CITY OF ANNANDALE PLANNING COMMISSION MEETING AGENDA

TUESDAY, MAY 7, 2024 5:30 P.M. COUNCIL CHAMBERS

Originating Department: Administration	Meeting Date: May 7, 2024	Agenda No. 3B.
Agenda Section: Public Hearing	Item: Consideration of a Request for Prelimin Pintail Preserve and Site Plan Review of Multifamily Apartment in the R-5 High Family Residential District. Applicant: Pintail Preserve LLC (Briand)	f a 58-unit Density Multi-

RECTANGULAR CATCH BASIN (2' X 3') SCALE: NTS

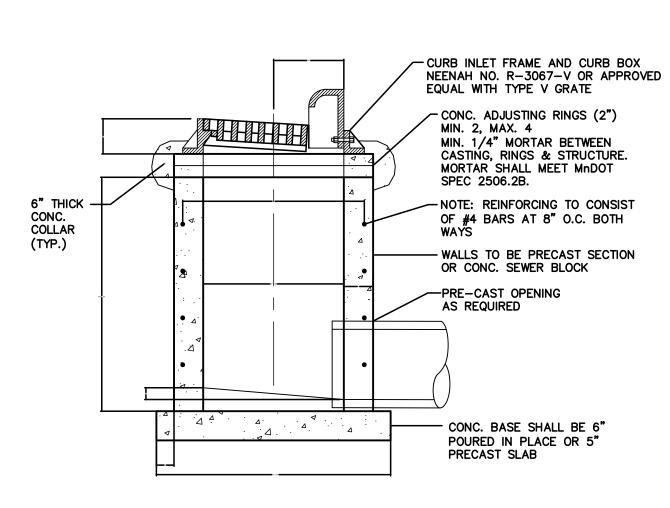
- 18. All catch basins shall accommodate a Neenah R-3250-1 castings. 2' X 3' structures will not be permitted. Change out detail #3 on Sheet C502.
- 19. All mortar used on concrete structures and adjusting rings shall be approved for underground utility use with 8 to 9% air entrainment.

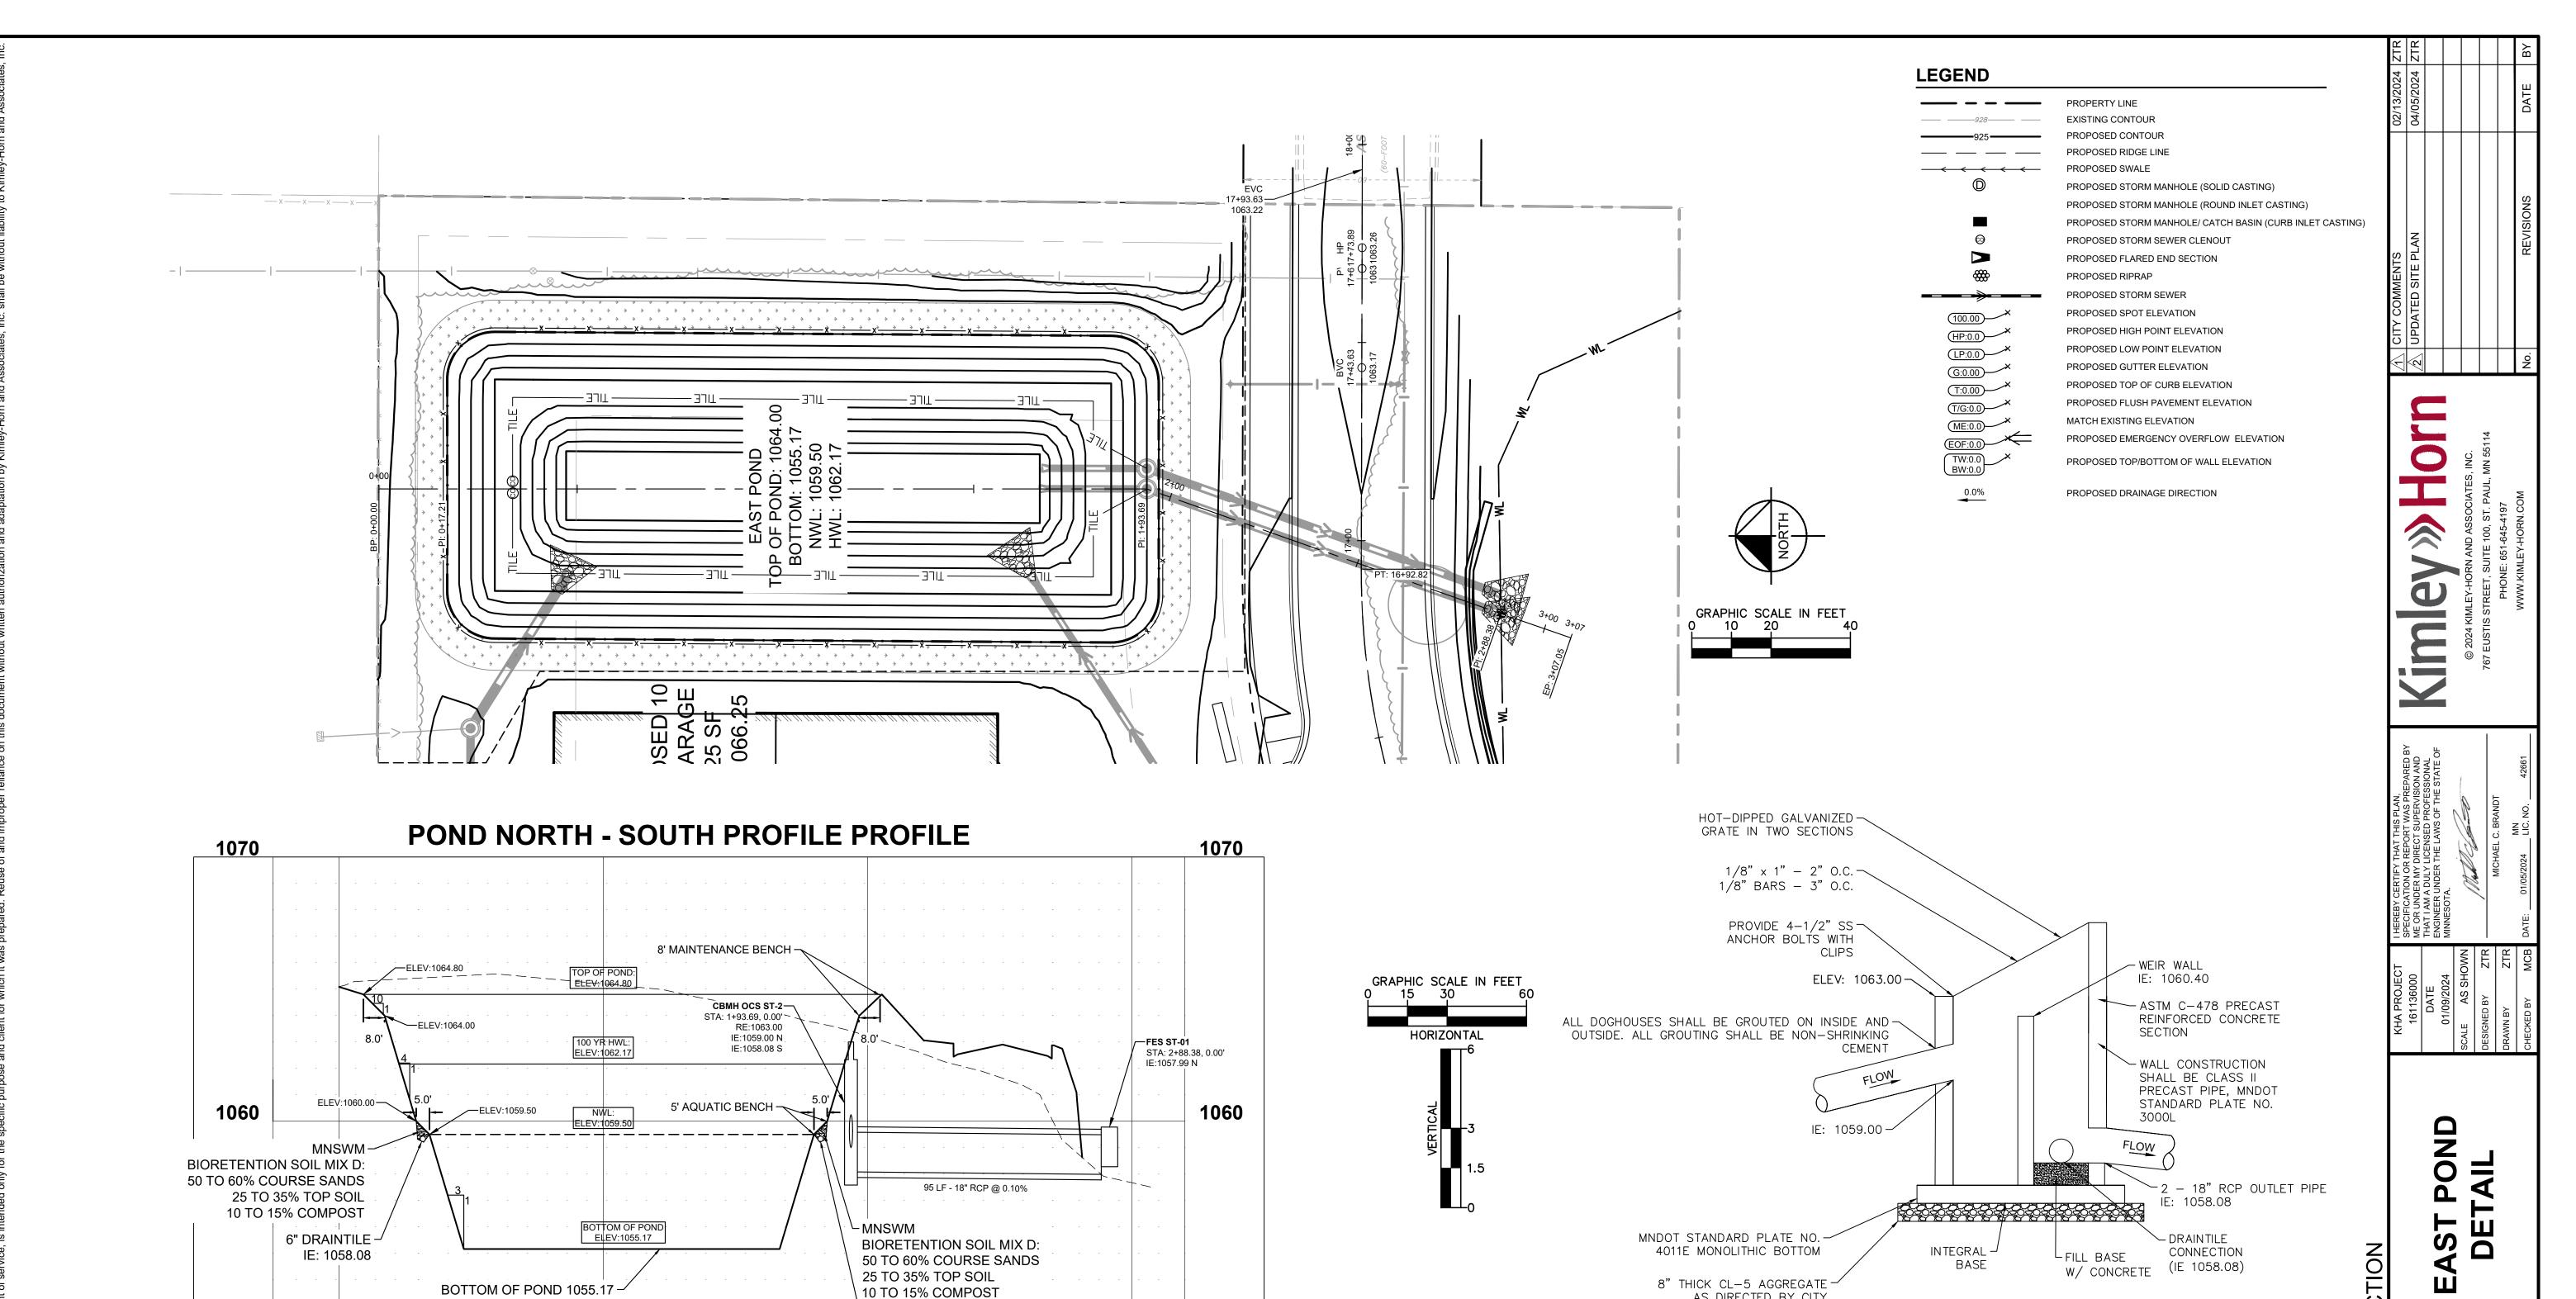
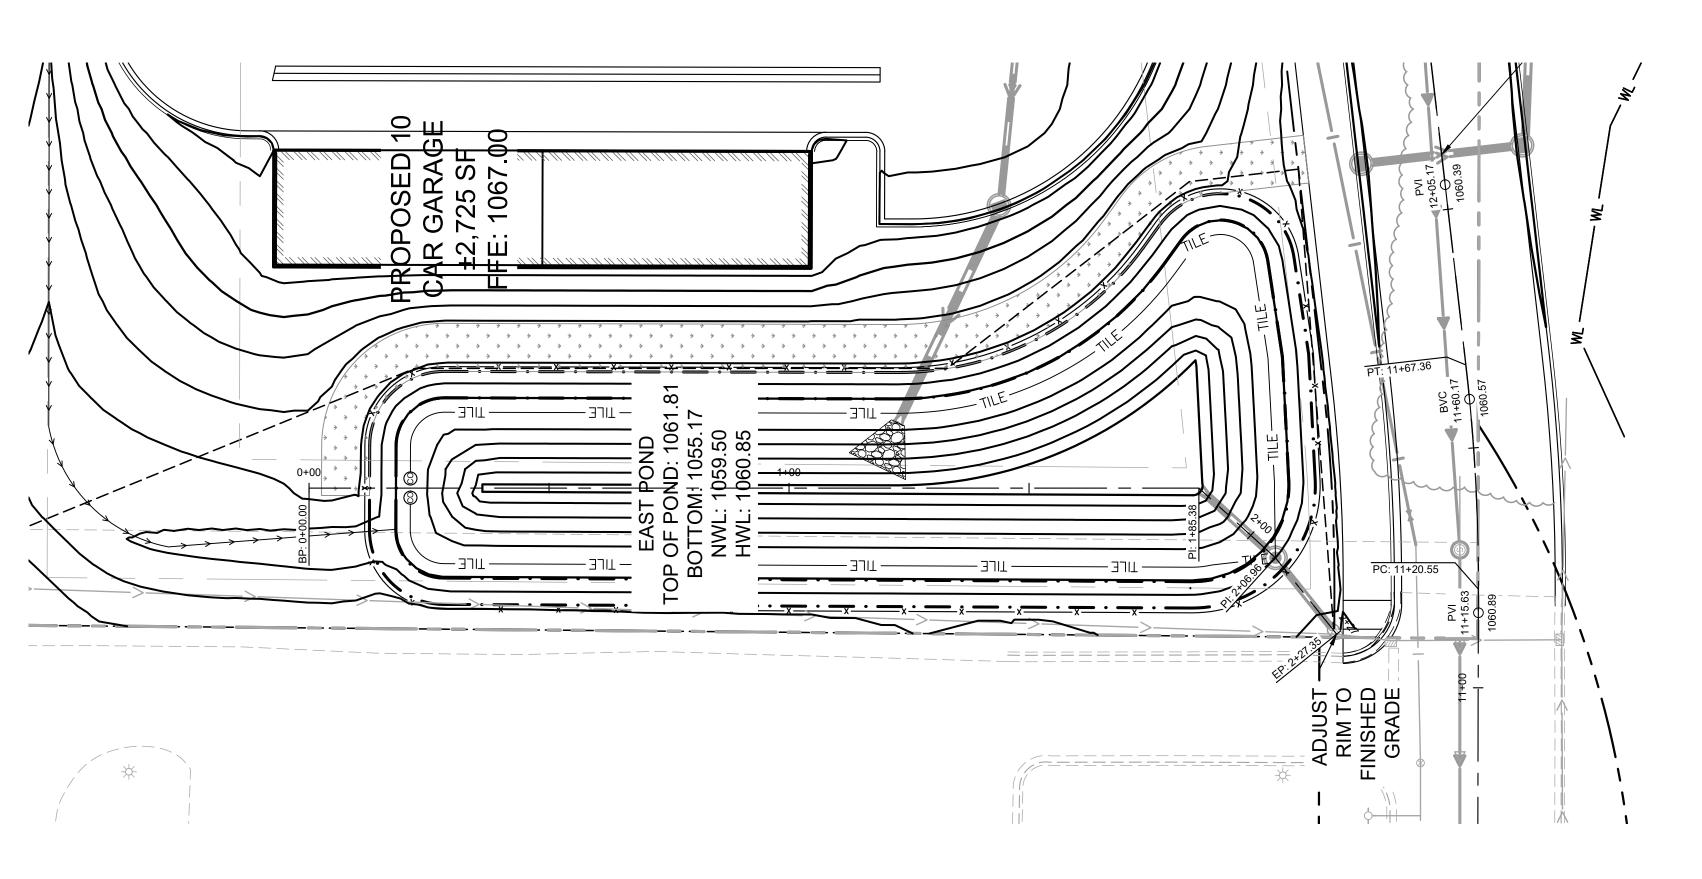
- 21. All manhole adjusting rings shall be HDPE and installed with the manufacturer's approved butyl sealant.
- 22. Sheet C500: Show an emergency overflow elevation east of CBMH ST-201 in case the casting on this structure becomes obstructed.

- 23. Sheet C500: The west pond is labeled the "East Pond", please correct this.
- 24. The wetland high water elevation shall be included on the grading and utility plan sheets.
